BOARD ACTION REPORT – APPEALABLE ITEM

Project Name:	8 East Atlantic Avenue
Project Location:	8 East Atlantic Avenue, Old School Square Historic District
Request:	Class II Site Plan Modification, Landscape Plan, Elevations and Certificate of Appropriateness
Board:	Historic Preservation Board
Meeting Date:	April 4, 2018

STAFF REPORT

ITEM: 8 East Atlantic Avenue, Old School Square Historic Arts District – Class II Site Plan Modification, Landscape Plan, Elevations and Certificate of Appropriateness (2018-042) for alterations to the front façade and improvements to the exterior dining area.

2 | PROPOSED OVERALL LANDSCAPE PLAN
A-103 | 1" = 10'-0"

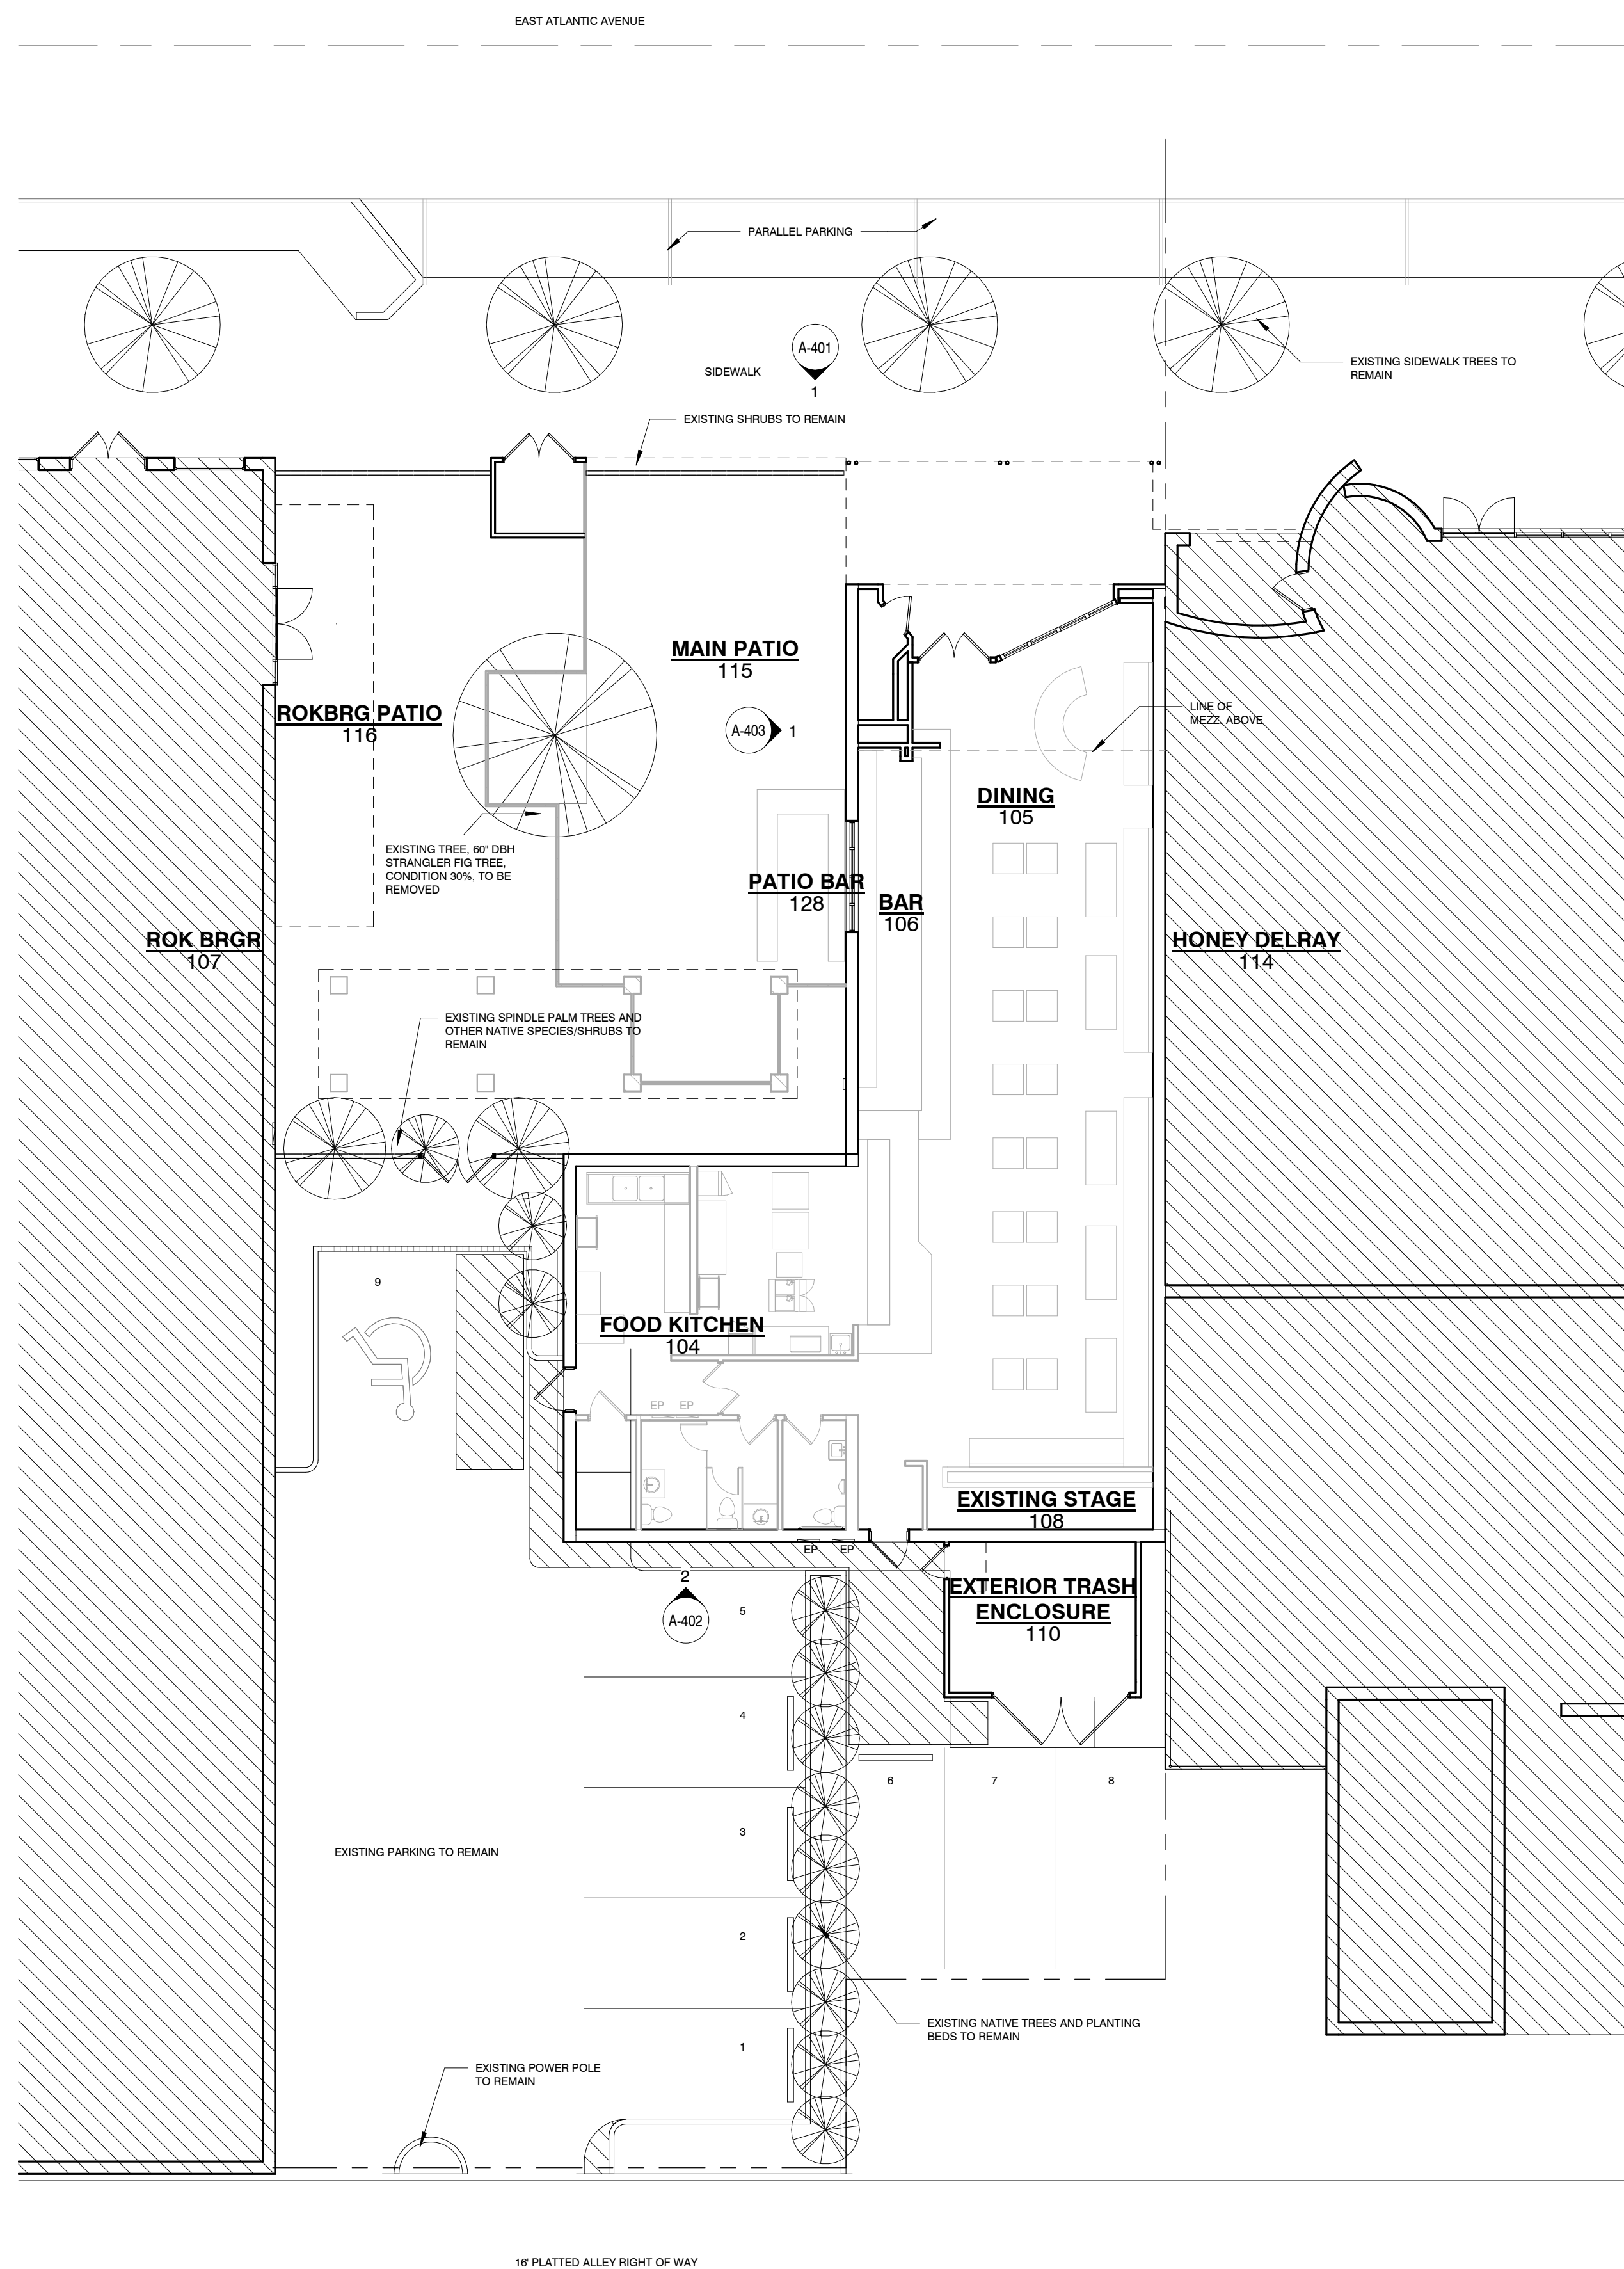
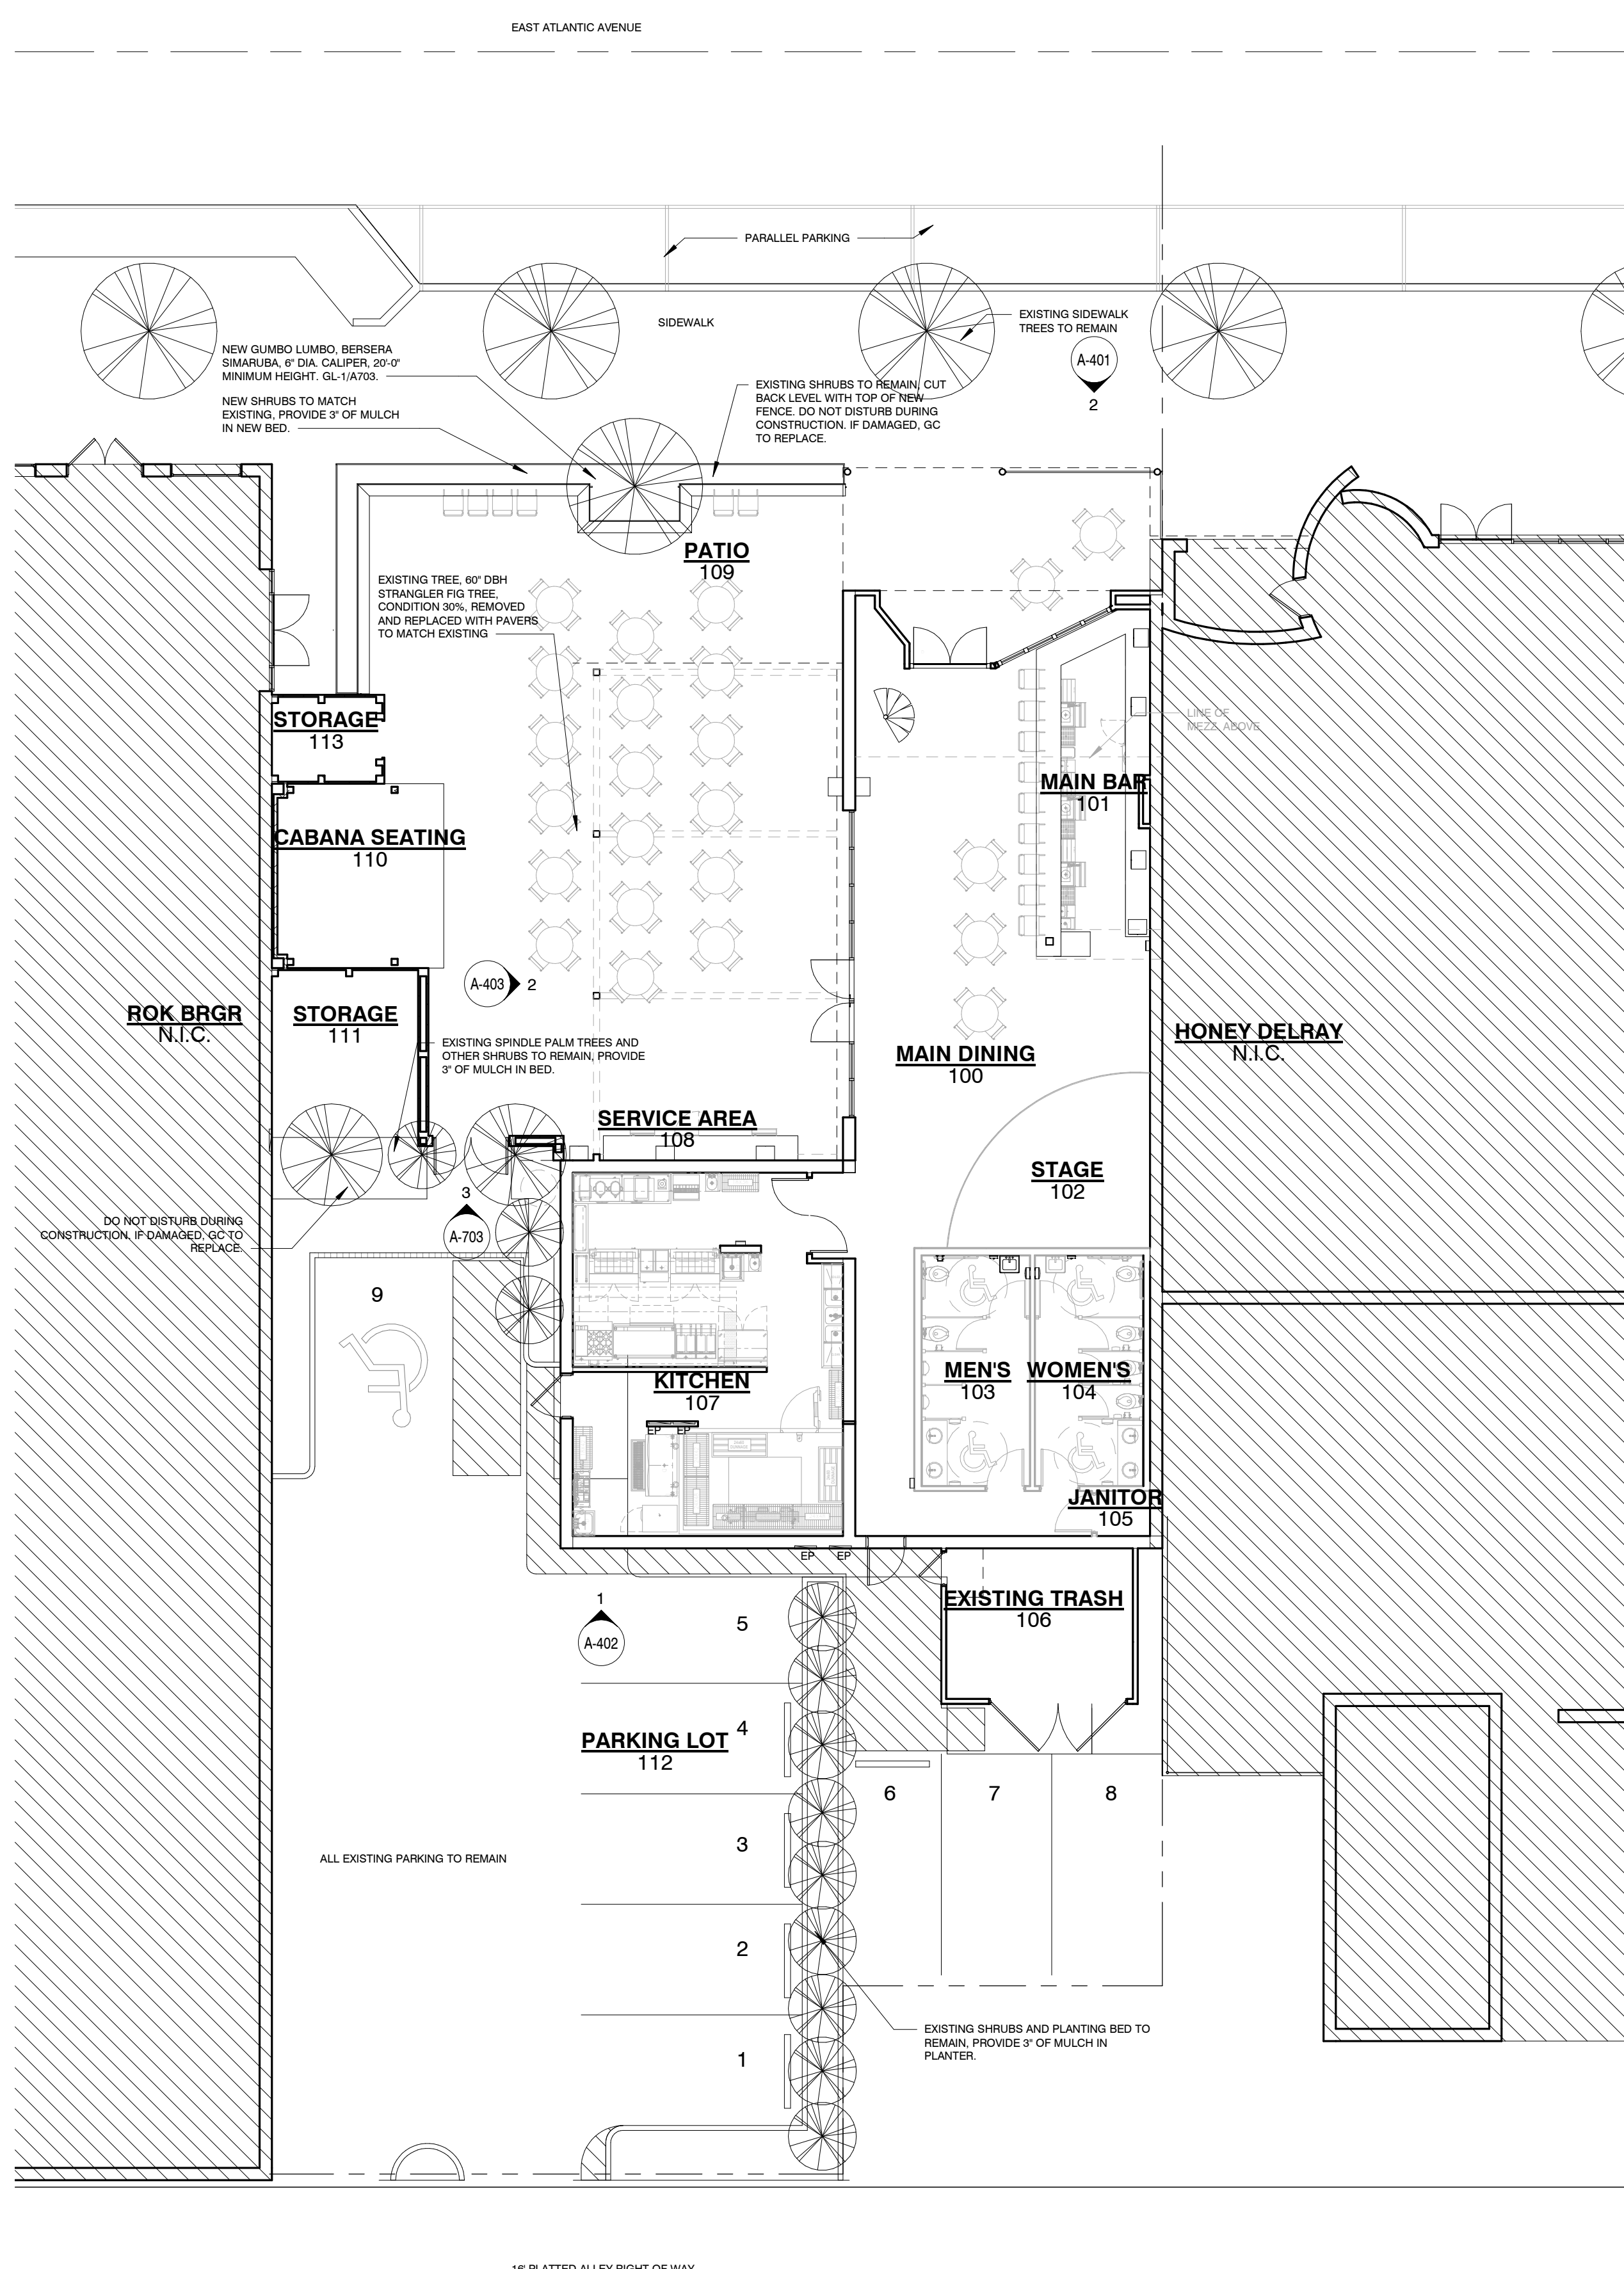
The proposal includes removal of the existing 60" DBH (diameter at breast height) Ficus tree located in the center of the exterior dining area on the West side of the building. The replacement tree is a Gumbo Limbo with 20 feet in overall height, 8 feet minimum single straight trunk with 10 feet of clear trunk, and a 9 to 10 foot spread of canopy which exceeds the code requirement. The new tree is proposed to be located along the North property line adjacent to the new horizontal aluminum railing.
